**Radioactive Waste Isolation in Salt: Peer Review
of the Office of Nuclear Waste Isolation's
Reports on Multifactor Life Testing
of Waste Package Materials**

**RADIOACTIVE WASTE ISOLATION IN SALT:
PEER REVIEW OF THE OFFICE OF NUCLEAR WASTE ISOLATION'S
REPORTS ON MULTIFACTOR LIFE TESTING OF
WASTE PACKAGE MATERIALS**

September 1984

FIGURE 1 Natural Log of Corrosion Rate versus Inverse of Temperature for Data of Tables 4 and 5

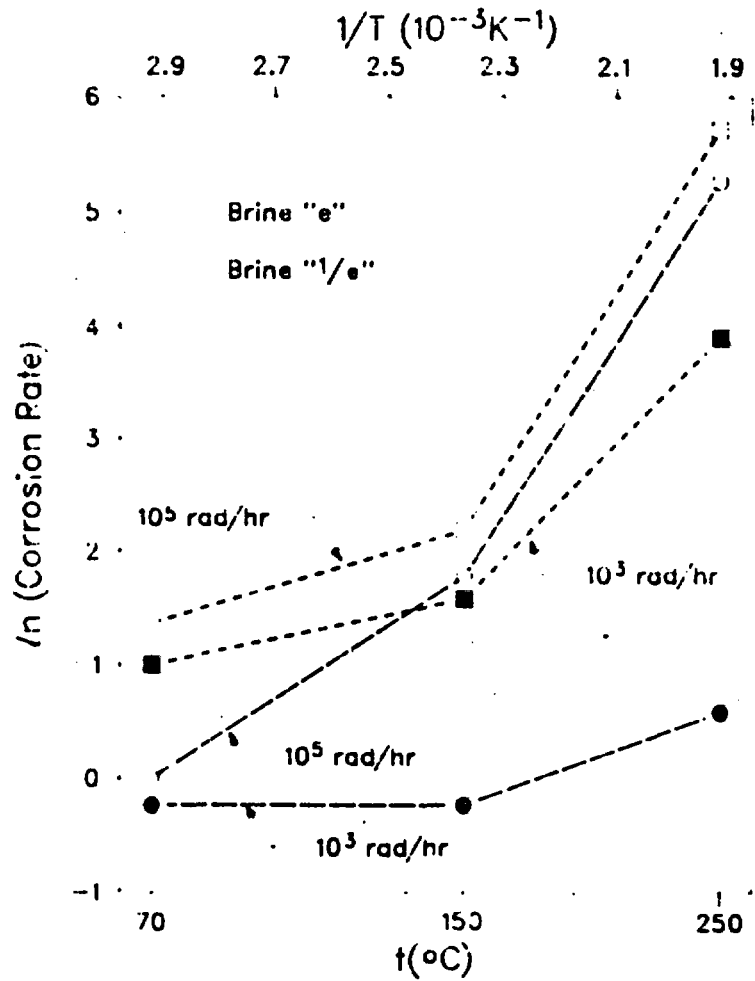
If the Eyring model held for the results, the three data points (three temperatures) for each consensus experiment would fall on a straight line. As Fig. 1 shows, however, considerable departures from linearity are clearly visible to the eye, with no need for statistical analysis of the data. Thus, a conclusion that the Eyring model does not apply to the data should be drawn for the entire set of the consensus estimates, not only for the high-temperature portion of the set.

For the three temperature data points (see Fig. 1), either the Eyring (or Arrhenius) model does not fit or the power exponents (B, D, F, and a) in Eqs. 1 and 2 are temperature dependent. Such a conclusion is obviously unsatisfactory.

One of the problems seems to lie in the definition of the stress factors. Brine composition is not a sufficiently precise stress factor, as explained earlier, and the

additional stresses originating from the irradiated host rock have not been explicitly included in the model. To test the applicability of the Eyring model, one must know more about the corrosion mechanism, which requires a better understanding of the chemical changes taking place in a system comprised of an iron alloy, salt brine, and a host rock. A departure from the simple Arrhenius, or Eyring, plot -- such as that shown in Fig. 1 -- may also indicate that the mechanism of the chemical reaction changes with temperature. If this is the case, understanding the relevant mechanisms is indispensable to successful modeling.
